12 October 2021

**Response to Request for Further Information - Planning Permit Application No. PA2000978, West Mokoan Solar Farm****1.0 INTRODUCTION**

**Figure 1 Factors Attributed to Inverter Noise Level**

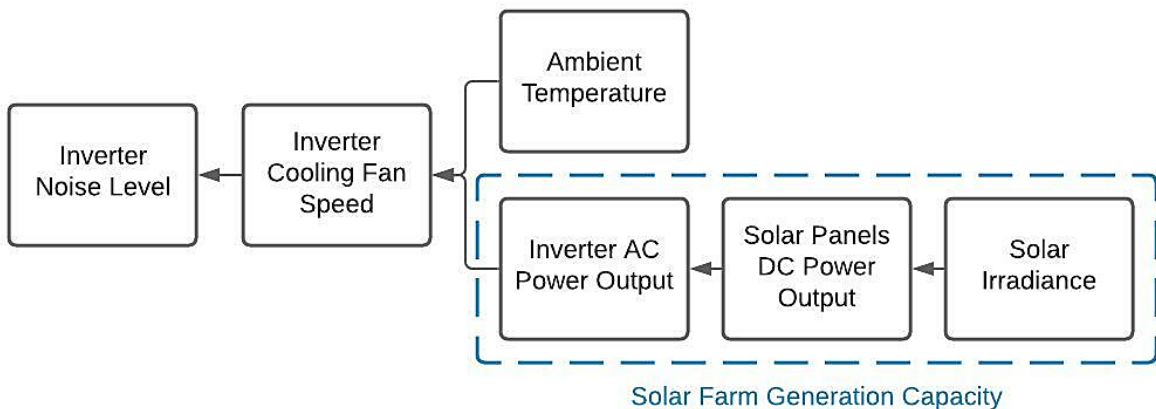
***The noise produced by the PCUs appears to be related to cooling fan operating speed. The data that has been provided is in relation to solar radiation. No correlation has been explained between these two factors and I couldn't assume there would be a linear relationship.***

Solar inverters contain many electrical components and therefore need to be kept cool in order to function properly. The noise produced by an inverter is predominantly related to its cooling fan operating speed (i.e. with greater fan speed comes greater noise emission).

The fan speed however is also related to ventilation requirements of the inverter in different working conditions, which include the ambient temperature and the amount of power generated by solar panels which the inverter needs to convert from direct current (DC) to alternating current (AC). The power from solar panels directly correlates with solar irradiance, subject to weather conditions and time of day. Figure 1 shows the relationship between these factors.
